SERVICE BULLETIN

SB-122722-B

ID NUMBER & REVISION: SB-122722-B
SUBJECT: NLG Actuator Rod End Torque
RELEASE DATE: 31 October 2025
EFFECTIVE DATE: 27 December 2022
SUPERSEDES NOTICE: SB-122722-A
AIRCRAFT AFFECTED: **MAKE & MODEL:** ICON A5
SERIAL NUMBERS: 00004 – 00015, 00017 – 00024, 00026 – 00074,
00076 – 00137, 00139, 00141 – 00142, 00144 –
00145, 00148 – 00150, 00152 – 00159, 00161,
00163, 00166

Figure 7 Mechanical Limit Switches

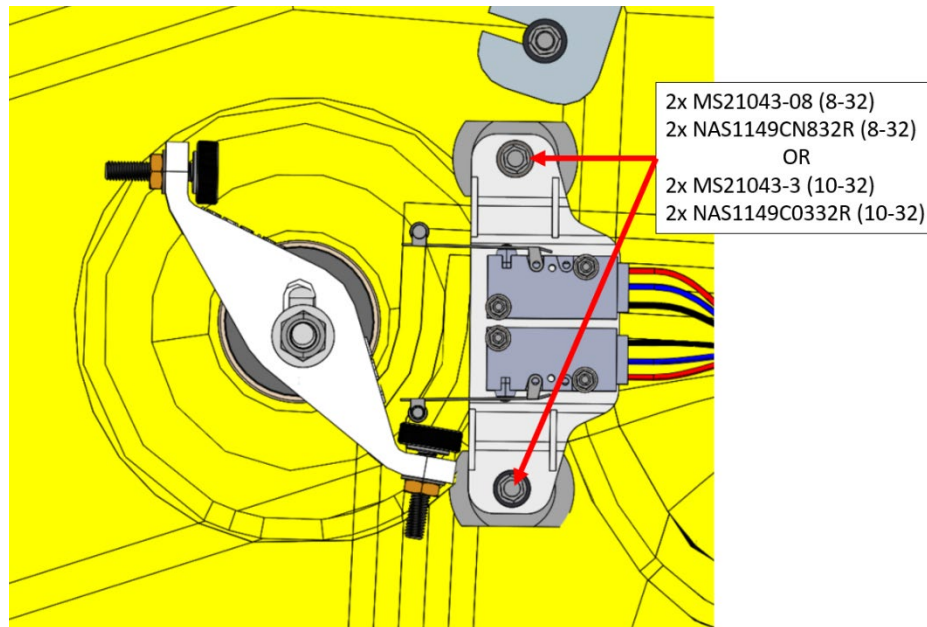
2. Remove the MLG fuse.
3. For aircraft with mechanical limit switches, loosen the two nuts securing the limit switch bracket assembly to the studs. Remove the switch and bracket assembly.

CAUTION: Failure to remove the switch assembly prior to releasing the NLG leg may result in damage to the limit switch arms.

13. If applicable, reinstall limit switch bracket assembly (*Figure 7*):
 - a. Using isopropyl alcohol, clean surfaces where lubricant will be applied.
 - b. Apply ICA012078 Tef-Gel to the threads of the studs.

- c. Install limit switch assembly onto studs with 2x NAS1149CN832R washers and 2x MS21043-08 nuts torqued to 14 in-lb (for 8-32 studs), or with 2x NAS1149C0332R washers and 2x MS21043-3 nuts torqued to 20 in-lb (for 10-32 studs).

Figure 3 FWD Hose Clamp and Actuator Rod End

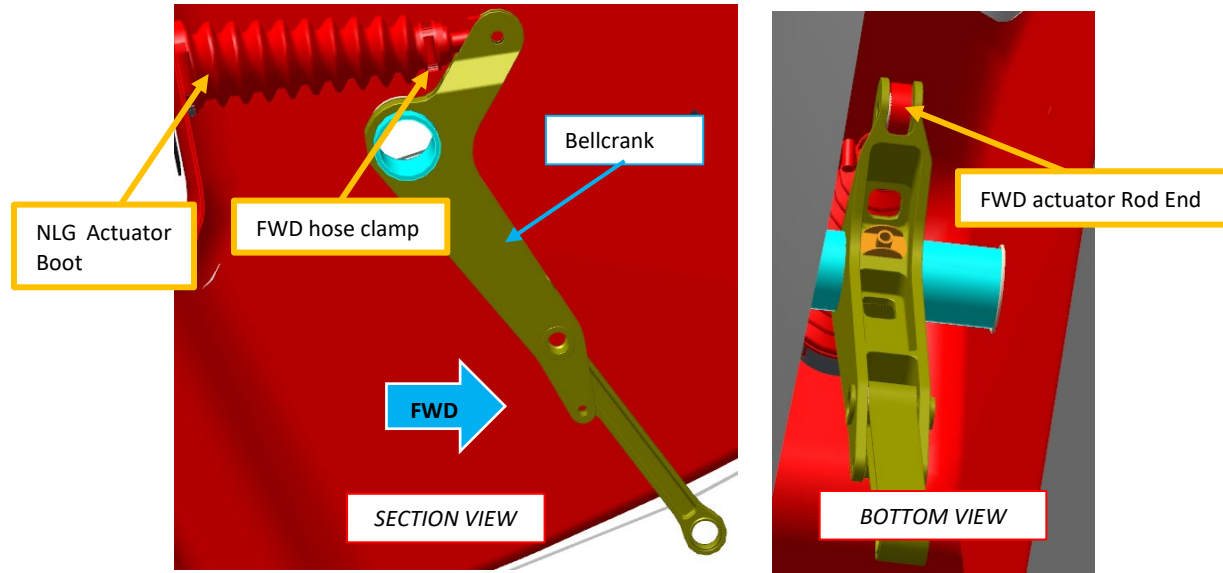
7. Slide boot (see Figure 3) back to expose NLG actuator rod end.
8. Remove FWD Actuator Bolt to validate Torque at FWD actuator Rod End, see Figure 4 for reference
 - a. Make note not to remove the bushing.
 - b. Verify and note the torque level on the jam nut.

Figure 5 NLG Actuator Rod End Jam Nut

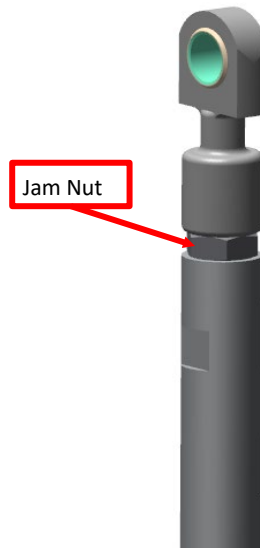
9. If the torque level of the jam nut is outside the allowable range (95-110 in-lbs) then:
 - a. Bottom the rod end onto the thrust tube. See Figure 5.
 - b. Torque the jam nut to 95-110 in-lbs.
